LAWRENCE HISTORIC RESOURCES COMMISSION
ITEM NO. 6: DR-15-00466
STAFF REPORT

DR-15-00466 1012 Massachusetts Street; Sidewalk Dining Railing; Downtown Design Guidelines Review. The property is located in the Downtown Urban Conservation Overlay District. Submitted by Vic Allred for Christie Brothers LLC, the property owner of record.

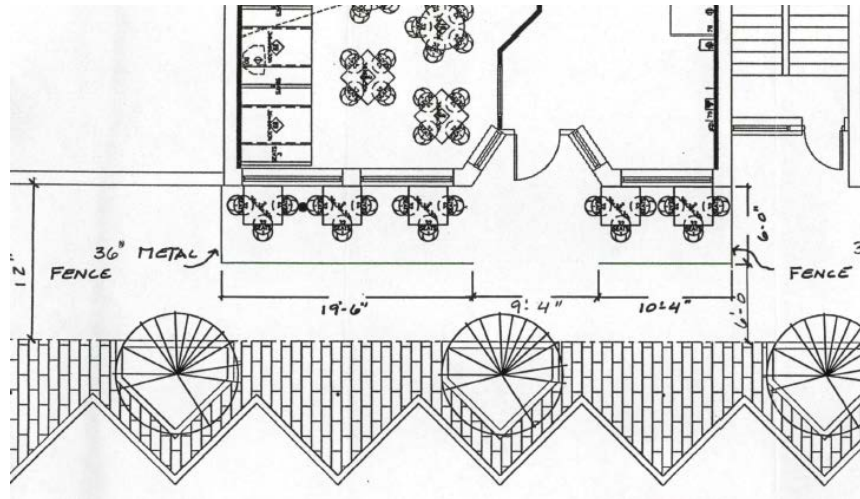
The original sidewalk dining application for the site was approved in 2003. The area was developed in accordance with the approved site plan.

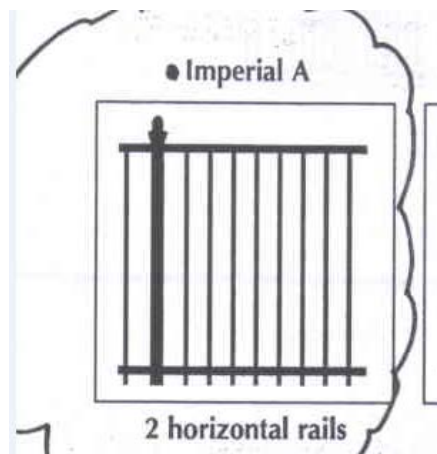
The railing that was proposed at that time is below.

The proposed railing type was never installed or was replaced with the railing in the photo below. The proposed site plan for the area and the proposed railing were approved as they did not alter the overall character of the historic downtown and the railing was similar to outdoor dining areas in downtown.
